1st Further Information

**Proposed Temporary Warehouse (Excluding Dangerous Goods Godown) with Ancillary Facilities
and Associated Filling of Land for a Period of 3 Years
in "Green Belt" Zone, Lots 1363 RP (Part) and 1364 (Part) in D.D.125
and Adjoining Government Land, Ha Tsuen, Yuen Long, New Territories**

(S.16 Planning Application No. A/YL-HTF/1211)

Responses-to-Comments

Annex II
Landscape Proposal

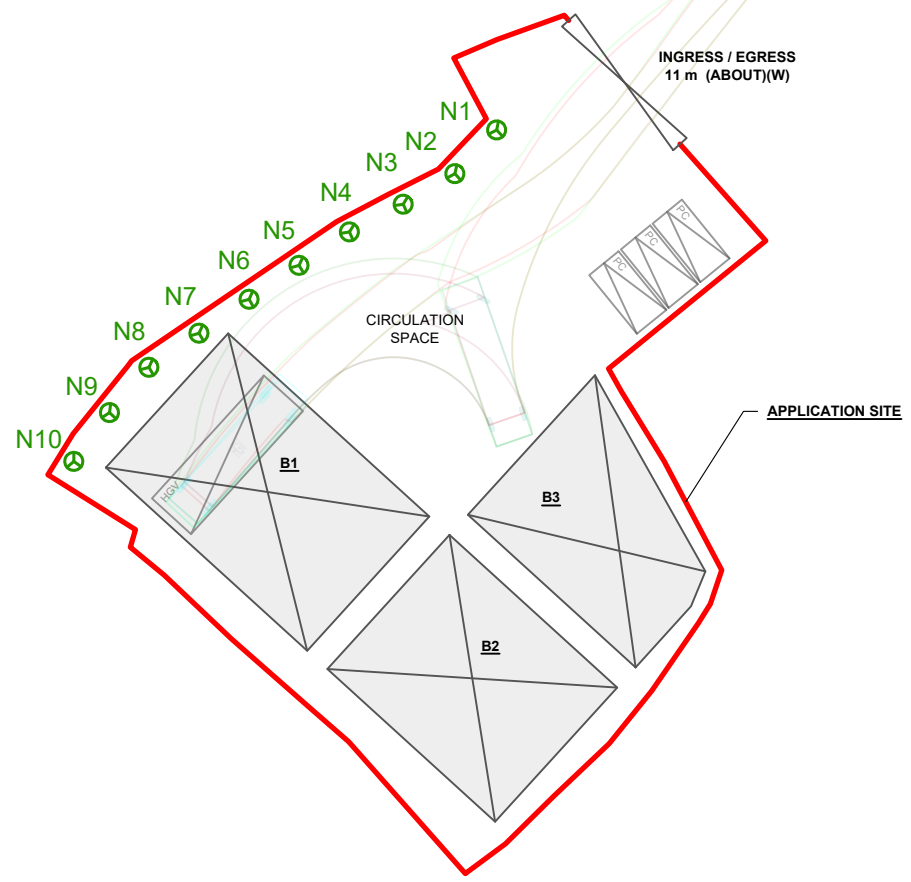
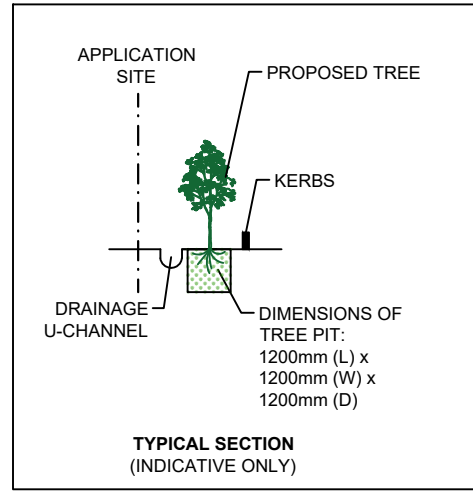
(a)	We have reservation on the application from landscape planning perspective. The Site is zoned "Green Belt" on the approved Ha Tsuen Fringe Outline Zoning Plan No. S/YL-HTF/12. It is considered that the proposed use would alter or further affect the landscape character of a green belt. Moreover, no Landscape Proposal is provided to mitigate the landscape impact of the proposed use.	A landscape proposal is submitted by the applicant to provide landscape mitigation measures for the proposed development (Annex II). A total of <u>10</u> new trees are proposed to be planted along the northwest periphery of the application site (the Site) as a landscape buffer to minimise adverse visual impacts to the surrounding areas. All these new trees within the Site will be well-maintained by the applicant during the planning approval period.

NO. OF NEW TREES WILL BE PLANTED	: 10	(N1 TO N10)
SPECIES OF NEW TREES	: POLYSPORA AXILLARIS	
HEIGHT OF NEW TREES	: NO LESS THAN 2.75 m	
SPACING OF NEW TREES	: NOT LESS THAN 4 m	
DIMENSION OF SOIL TRENCH	: 1.2 m (L) X 1.2 m (W) X 1.2 m (D)

- NOTES:**
- 1) THE APPLICANT WILL MAINTAIN TREES IN GOOD CONDITION DURING THE PLANNING APPROVAL PERIOD.
 - 2) THE APPLICANT WILL REPLACE TREES WHICH ARE DYING OR DEAD DURING THE PLANNING APPROVAL PERIOD.
 - 3) THE APPLICANT WILL PROVIDE ADEQUATE IRRIGATION FOR TREES.

Plan 1

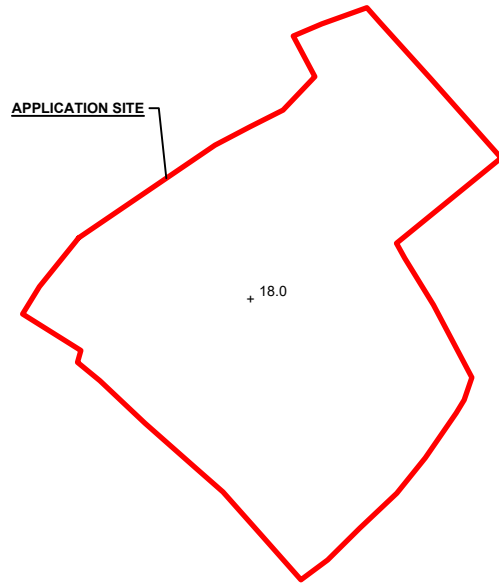
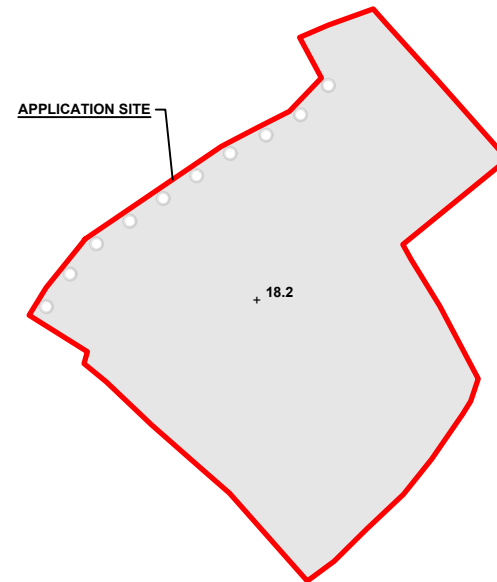
- (a) Revised application form and filling of land plan are provided by the applicant to facilitate the application (**Annex I** and **Plan 1**).
- (b) To minimise the potential nuisances generated from the proposed development, all goods will be stored within the enclosed structures. No workshop activities will be carried out within the Site at any time during the planning approval period.
- (c) A RtoC Table:

APPLICATION SITE AREA : 1,379 m² (ABOUT)
 FILLING OF LAND AREA : 1,367 m² (ABOUT)
 MATERIAL OF FILLING : CONCRETE
 DEPTH OF LAND FILLING : NOT MORE THAN 0.2 m
 SITE LEVELS : +18.2 mPD (ABOUT)
 USE : PARKING AND LOADING / UNLOADING SPACE,
 SITE FORMATION OF STRUCTURES AND
 CIRCULATION SPACE
